ADDENDUM NO. #0

TRACK & FIELD IMPROVEMENTS

LITTLE JOB #612-12353-06

Oxnard High School

SHEET NUMBER
C5.1 **AD0-C12**

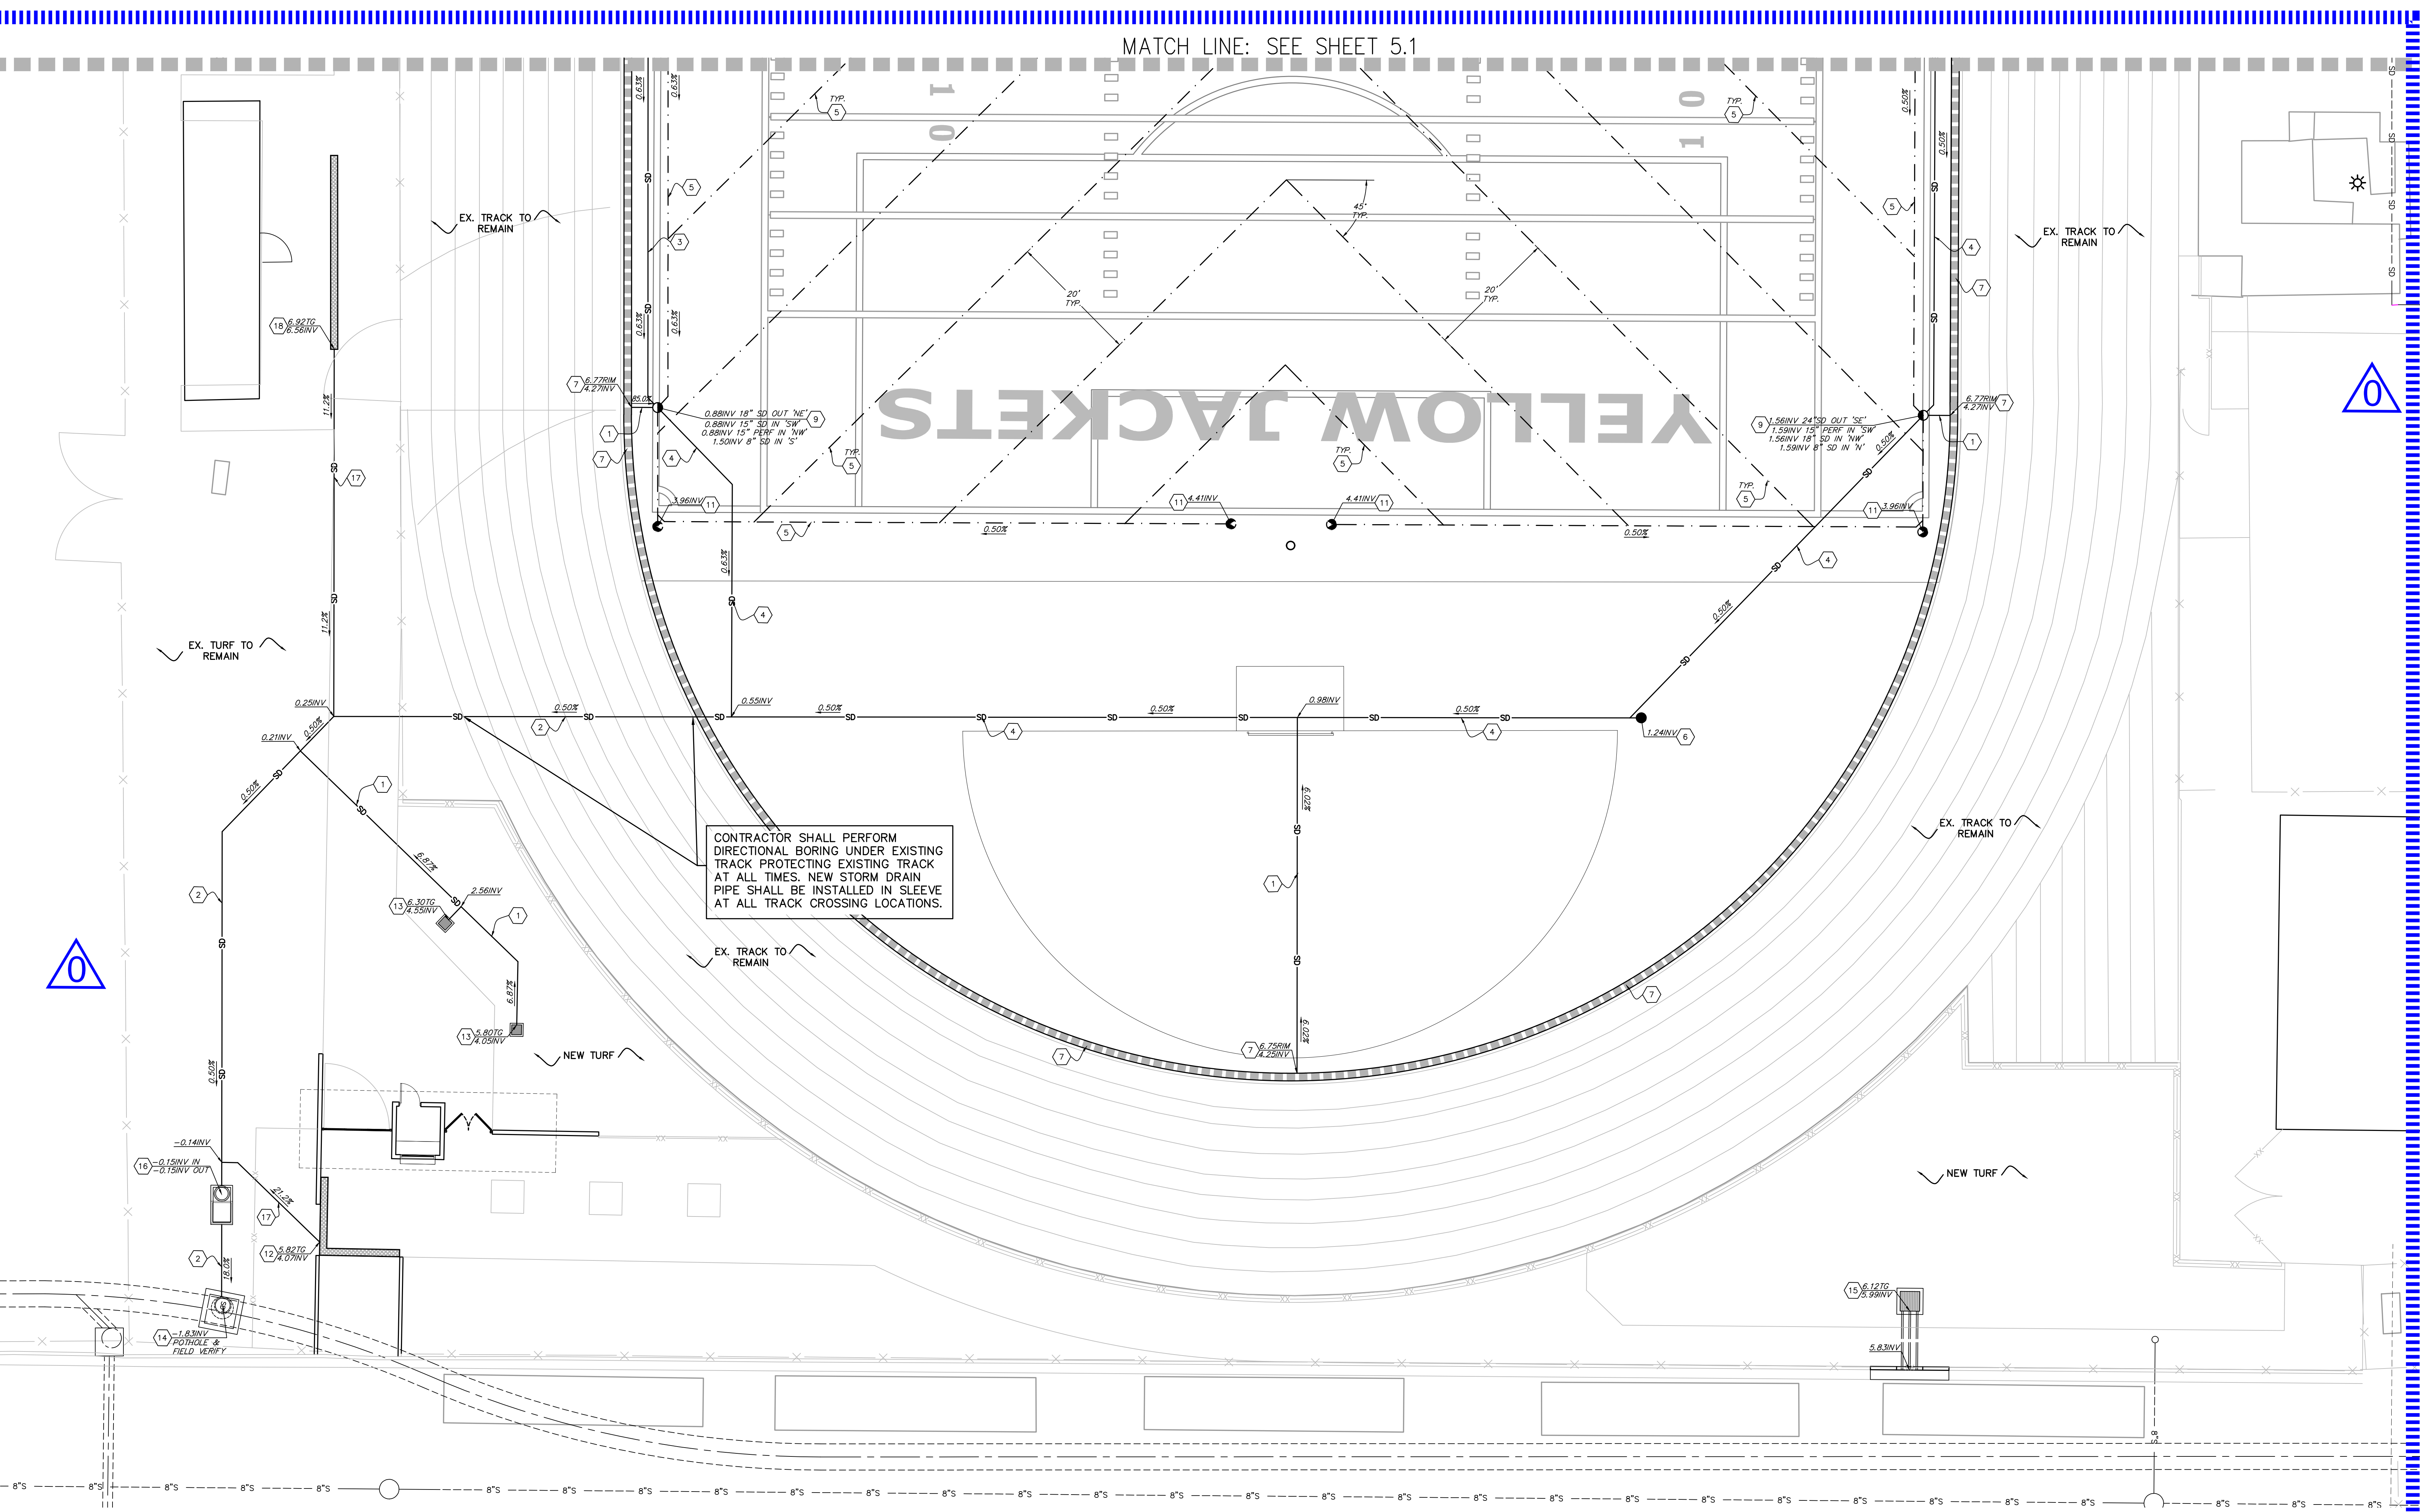
- 3.1.2.12.** Drawing C5.1/AD0-C12 - Only work within outlined area is included in scope of this project and bid. Any work shown outside of the delineated area is not part of this project.

C5.2 AD0-C13

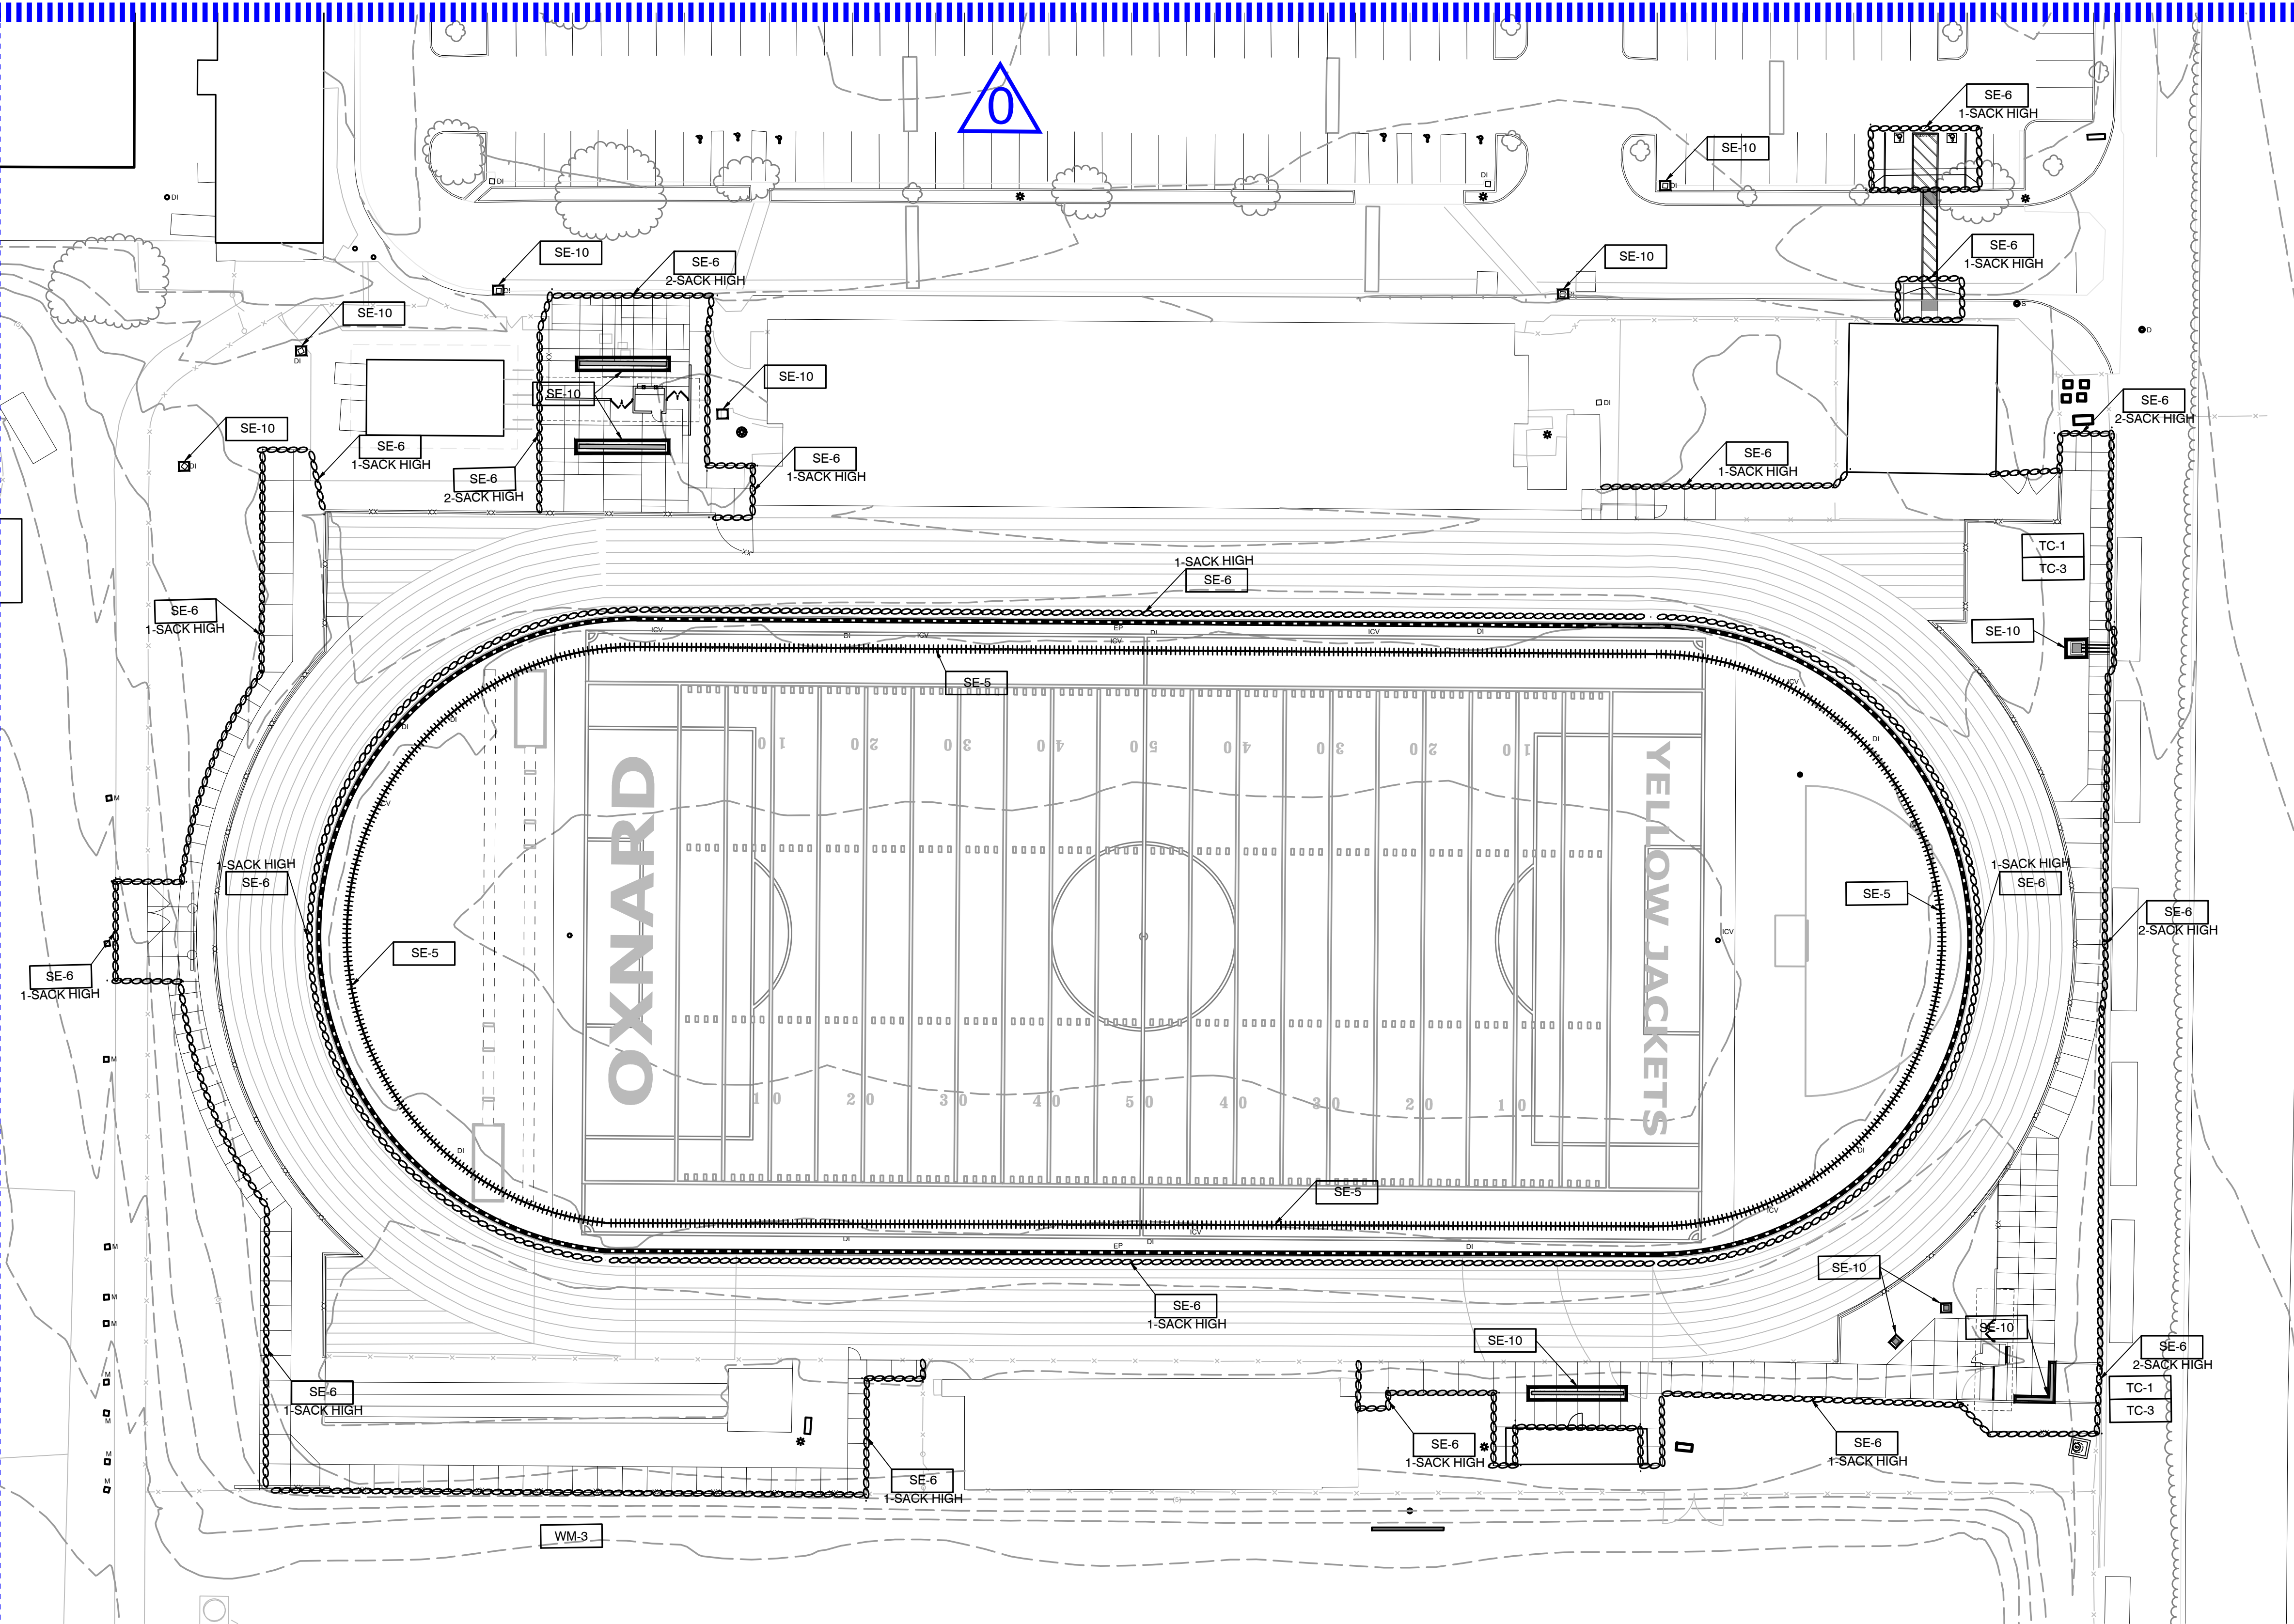
- 3.1.2.13.** Drawing C5.2/AD0-C13 - Only work within outlined area is included in scope of this project and bid. Any work shown outside of the delineated area is not part of this project:
- 3.1.2.14.** Drawing C6.0/AD0-C14 - Only work within outlined area is included in scope of this project and bid. Any work shown outside of the delineated area is not part of this project.
